| Request | - | Special Use Permit for Community Recreation (Active) |
| Location | - | 1030 & 0 Water Street |

The staff recommends that the Toledo City Plan Commission recommend approval of SUP-12002-23, a Special Use Permit for community recreation (active) at 1030 & 0 Water Street, to the Toledo City Council, for the following two (2) reasons:

SPECIAL USE PERMIT
TOLEDO CITY PLAN COMMISSION
REF: SUP-12002-23
DATE: February 8, 2024
TIME: 2:00 P.M.

SITE PLAN

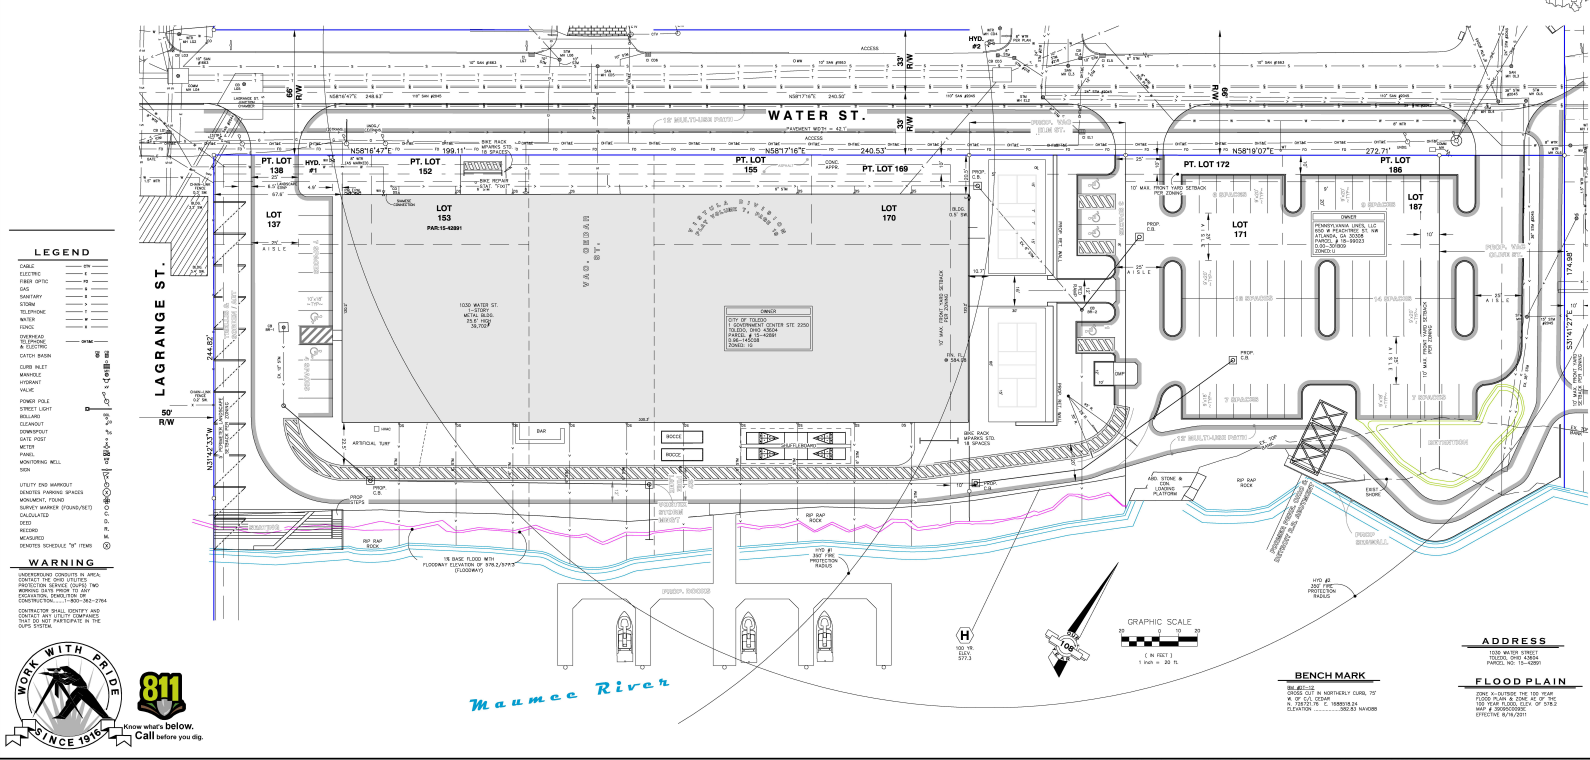
TMC§1103.1212 allows parking on the side of a building only when parking in the rear of the lot is not feasible. Parking in the rear of the lot is not feasible as the building is too close to the Maumee River. When this is the case, TMC§1103.1212 C requires the installation of a screening wall and landscape treatment along the street frontage. The shown hedge and landscaping buffer is acceptable as depicted.

TMC§1107.1202 B prohibits off-street parking facilities within fifteen (15) feet of street rights-of-way, except for approved driveways from streets. The site plan shows the parking lot/facility on the east as only ten (10) feet from Water Street's right-of-way. Staff is supportive of a waiver to allow the parking facility to be only ten (10) feet from Water Street's right-of-way as a twelve (12) foot multi-use path and appropriate landscaping – including street trees, turf grass, and an evergreen hedge – will be installed between the proposed parking facility and the street itself.

The dumpster shown on the site plan shall be screened with a minimum height of six (6) feet on all sides in accordance with TMC§1108.0304 B *Dumpsters and Trash Receptacle Screening*. The screen should incorporate access to the dumpster by using a wooden fence or other opaque device to serve as a gate. Screening materials can be any combination of evergreen plantings, fence or wall structure.

Approve waiver to allow parking facility ten (10) feet from street right-of-way. Additional separation and screening is provided in the right-of-way, along with a solid three (3) to four (4) foot evergreen hedge within the ten (10) foot separation.

LANDSCAPE PLAN

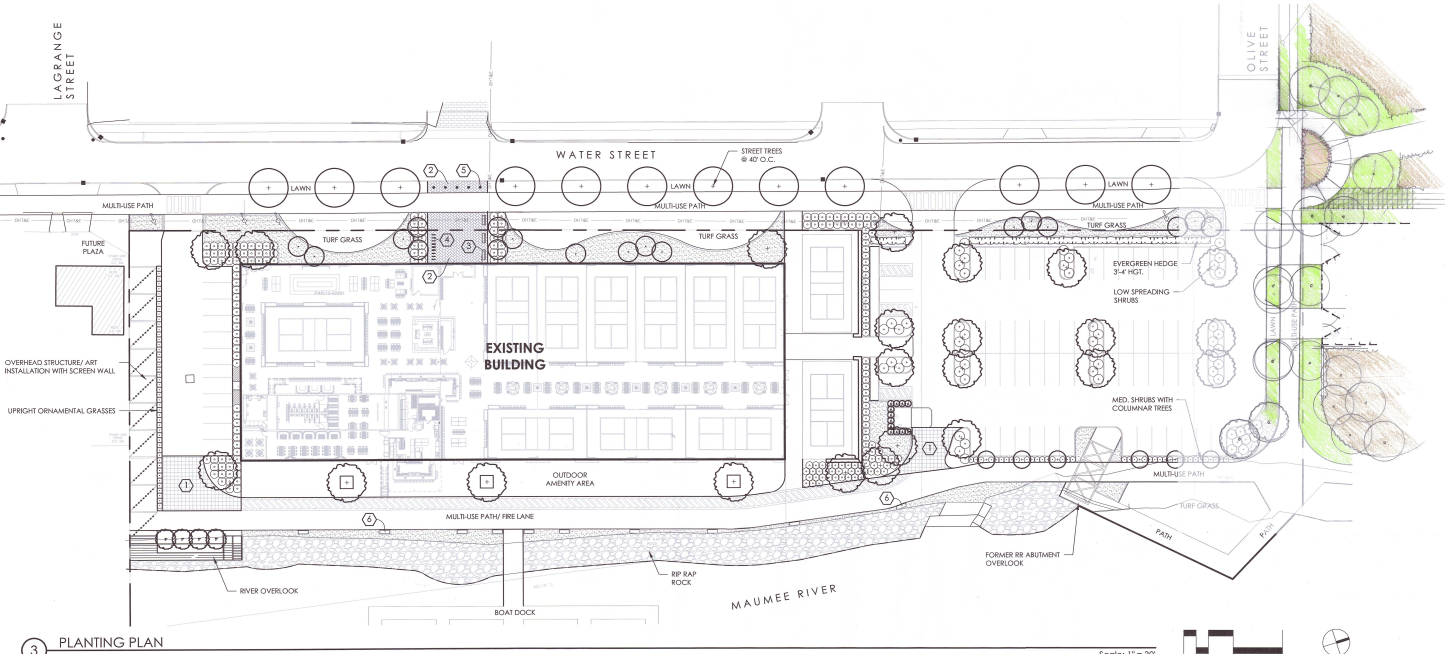
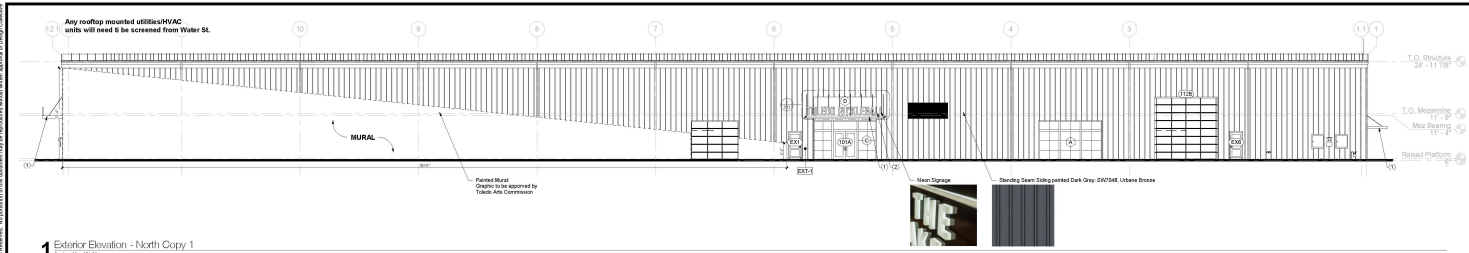
Land use buffers are necessary to ensure effective buffering and screening between potentially incompatible land uses. Property lines abutting parcels zoned IG General Industrial shall be required to include a land use buffer consisting of a solid evergreen hedge, decorative masonry wall, or alternative of equal quality, subject to approval of the director. The Overhead structure / art installation with screen wall on the western property line is acceptable. The separation (consisting of a multi-use path) and ornamental trees on the eastern property line is also acceptable as the adjacent parcel zoned IG (General Industrial) is currently used as a large city-owned detention basin and pumping station which visually looks like an open field. This open field above the detention basin is also proposed to a future extension of the Glass City Riverwalk.

Perimeter landscaping must be installed along any parking lot area adjacent to a street, place, or driveway pursuant to TMC§1108.0305 *Parking Lot Landscaping*. Perimeter landscaping shall consist of a landscaped area at least five (5) feet wide planted with at least one shrub for every three (3) to five (5) feet of property line. Both parking lots shown on the landscaping plan are acceptable – the eastern parking lot is acceptable as it provides a solid three (3) to four (4) foot evergreen hedge in lieu of shrubs.

- a. Any part of the lot area not used for buildings, other structures, or for roads, walks, parking, service areas or accessways must be landscaped with a combination of groundcover, trees, and shrubs. Grass may be used in conjunction other plant material. **Acceptable as depicted.**

- b. Landscape improvements must be provided in the sidewalk or other paved area in front the building in the form of one shrub or understory tree for every 30 feet of lot frontage. Such plantings may be in the right-of-way pursuant to TMC§1108.0303. **Acceptable as depicted.**

BUILDING ELEVATIONS

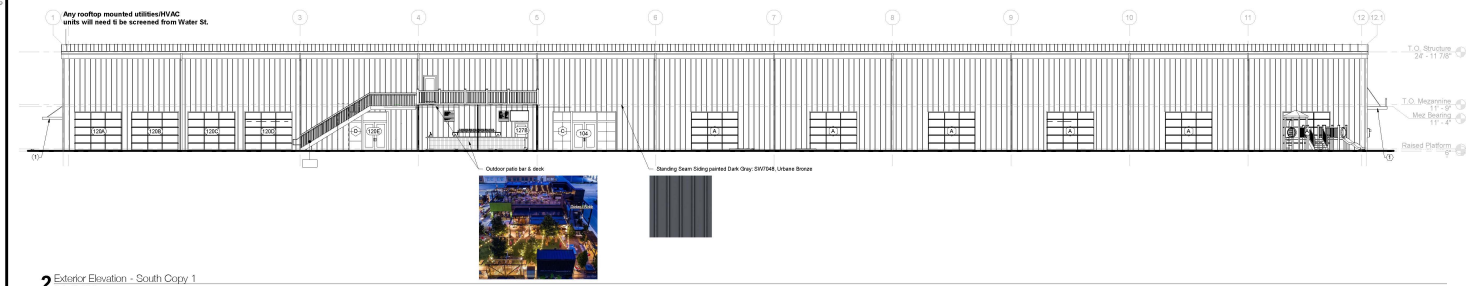
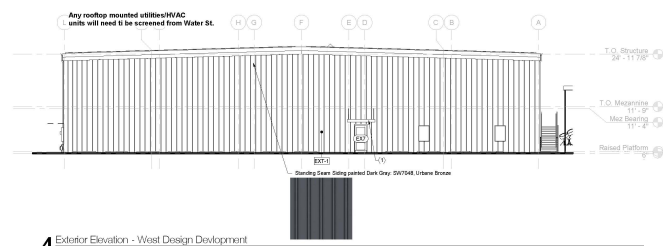
The existing structure has no variation in massing, little to no character, and is comprised almost entirely of pre-engineered metal siding – a prohibited material under TMC§1109.0500 *Building Façade Materials and Color*. As such, this building does not meet the requirements of either TMC§1103.1209 or TMC§1109.0200. Since this is a redevelopment of an existing building, however, the building design must simply come closer into compliance with the relevant sections. The applicant proposes to add character and massing to the building by constructing windows, awnings, and an outdoor patio bar & deck. The applicant also proposes a large mural spanning nearly half of the building's façade, which will bring further life to an otherwise dull building. The mural, however, will need to be approved by the Toledo Arts Commission as a condition of approval. The remaining pre-engineered metal siding would then be painted Urbane Bronze – a color similar to other buildings in the Summit Street Corridor Redevelopment UNO District. The proposed façade changes bring the existing structure closer to compliance with both TMC§1103.1200 and TMC§1109.0200.

TMC§1103.1216 prohibits signage on awnings. Elevations show signage on both the northern main entrance awning and the eastern side entrance awning. Staff supports a waiver of this prohibition as the awning signs add much needed depth to this redevelopment.

Approve waiver to allow awning with signage as the proposed design adds much needed depth to the existing building.
